SERVICE LETTER

No. 51
Nov. 15, 1996

TO: All users of Onboard Systems P/N 528-010-00.
(Talon 3500 lb. Cargo Hook)

SUBJECT: Drain Holes

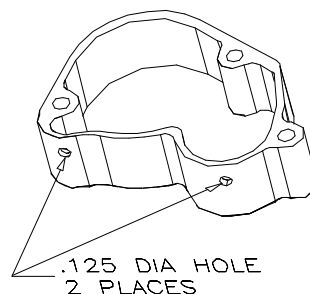
REASON: To Prevent Manual release mechanism from filling with water and freezing and interfering with manual release function.

It is possible for the area of the hook that encloses the manual release mechanism to become partially filled with water when washing the aircraft or from driving rain. The water enters around the hole for the manual release lever. The water can lay in the bottom of the chamber and later freeze. The ice could jam the manual release cable and mechanism. To prevent this from occurring we have added drain holes to the P/N 290-299-00 cover on production units from S/N 029 and on. For serial numbers 028 and lower we are recommending that two .125 dia. holes be drilled in the P/N 290-299-00 cover. Touch up the holes with Alodine after drilling.
